BCA ASSESSMENT REPORT

**PROPOSED WAREHOUSE FACILITY
42 Raymond Ave, Matraville**

Revision 4

Date: 05.07.2022

Figure 3 – Fire Stair discharge paths within 6m of external walls

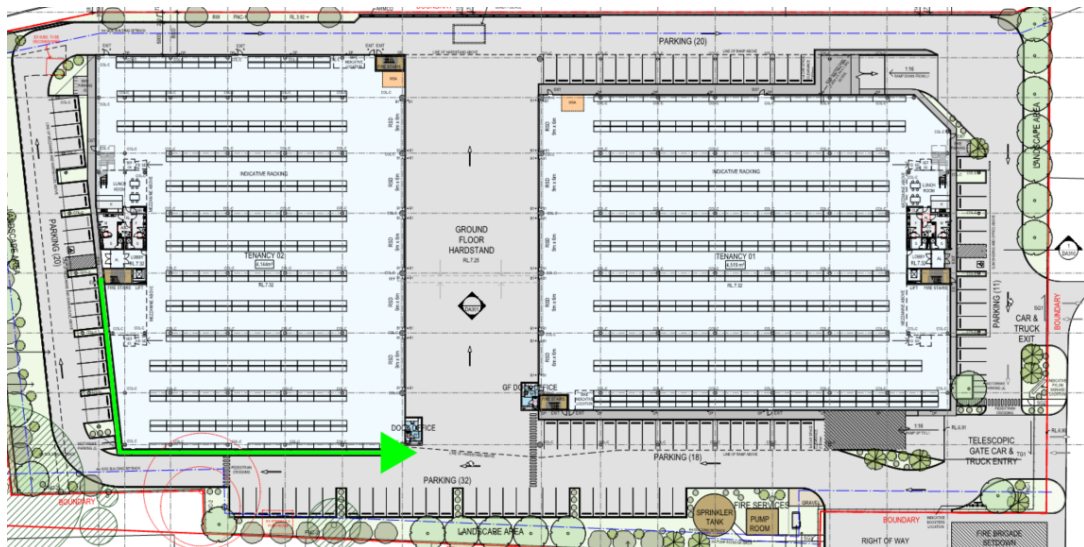
Comments: The discharge of the fire isolated exit serving the office levels comply with the above requirements of D1.7, however, as the discharge paths from the fire stairs serving Office Tenancy 02 & 04 will pass within 6m of the external walls of Warehouse Tenancy 02, either fire rated walls or a Performance Solution will be required.
